N00101.AR.003188
NAS SOUTH WEYMOUTH
5090.3a

U S NAVY RESPONSE TO THE U S EPA REGION I COMMENTS ON THE BUILDING 81
UTILITY SURVEY AND PREFERENTIAL FLOW INVESTIGATION WORK PLAN
07/02/2015
RESOLUTION CONSULTANTS

Navy Response to Comments (RTCs), July 2, 2015
Building 81 Utility Survey and Preferential Flow Investigation Work Plan,
February, 2015
Former NAS South Weymouth, MA

Environmental Protection Agency (EPA) Region I
Comments, March 18, 2015

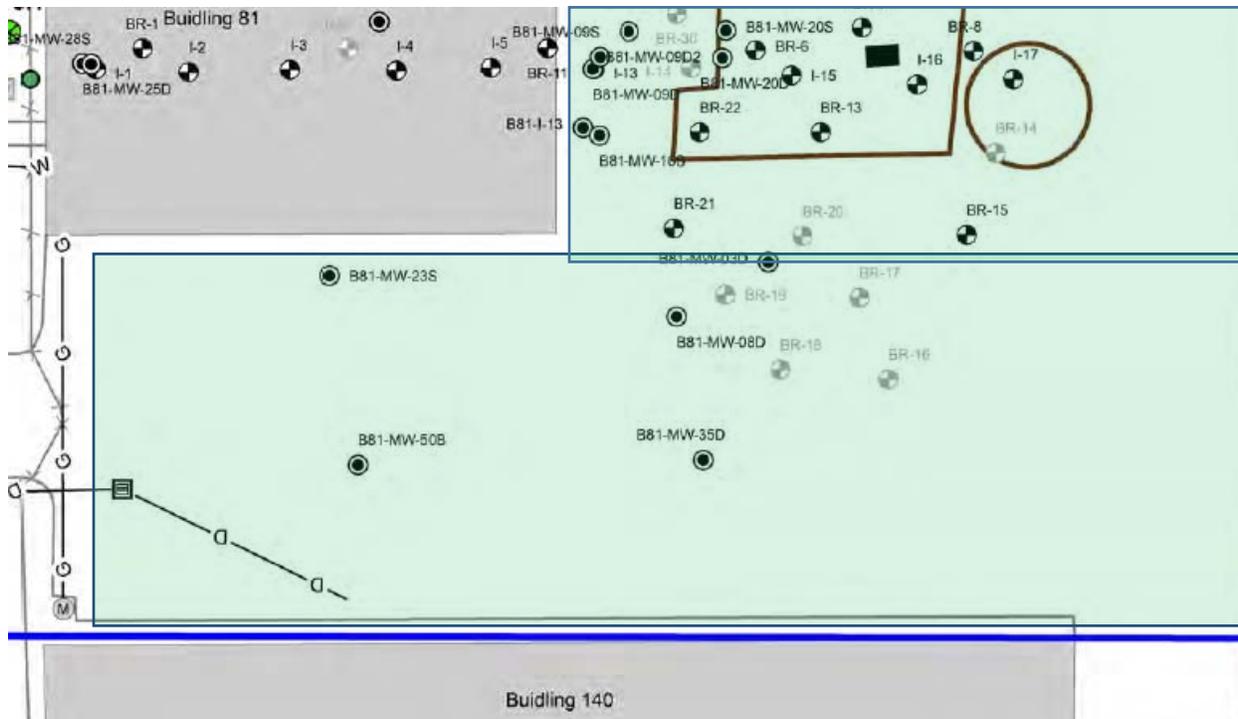
7. *Hydraulic monitoring points: Additional drive point locations beyond the 6 proposed in the text are needed in order to resolve the site hydrology, let alone contaminant distribution uncertainties. It is highly unlikely that the proposed 6 “profile” borings specified in the work plan will provide sufficient resolution on utility influences on groundwater to identify preferential pathways should they exist. Further, the chemical results to be collected from the vertical profile samples will not be interpretable in the absence of a more fully resolved picture of the shallow groundwater hydrology. For example, (one plausible scenario), identification of CVOCs at proposed locations GP-UI2 and GP-UI3 and absence or very limited levels of CVOCs at GP-UI5 and GP-UI6 (e.g., similar to past sampling results), would simply confirm the current limited understanding of the role of underground utilities, and would not rule out the possibility of NSUC 1 or NSUC 2 acting as preferential pathways. It is possible that these utility corridors are acting as “drains”, which effectively “relocate” contaminated water to the south, or perhaps they are having the opposite effect (e.g., as ground water “mounds”), which would also tend to inhibit groundwater flow from east-to-west. While either scenario could explain the east-west CVOC distribution at the site, neither would be consistent with the groundwater flow depiction as presented in the current CSM. In order to address the potential for preferential flow with respect to the several utility corridors, let alone the specific utilities, a much greater number of piezometers than the current work plan allows for will be required. EPA’s initial recommendations for proposed locations are shown in the figure attached below (see Figure EPA 1), and discussed further in the following comments.*

Response: The additional piezometers recommended by EPA were discussed in the May 7, 2015 Project Managers meeting and it was agreed additional investigation, including piezometer installation, could be pursued after injections, if warranted. As discussed

above, Navy proposes a phased approach to the Utility Survey and Preferential Flow Investigation with the immediate goal of determining if PCE is entering the utility corridor now. Additional piezometers will be installed at each proposed vertical profiling point. If PCE migration in utility corridors is suspected, installation of additional piezometers may be pursued.
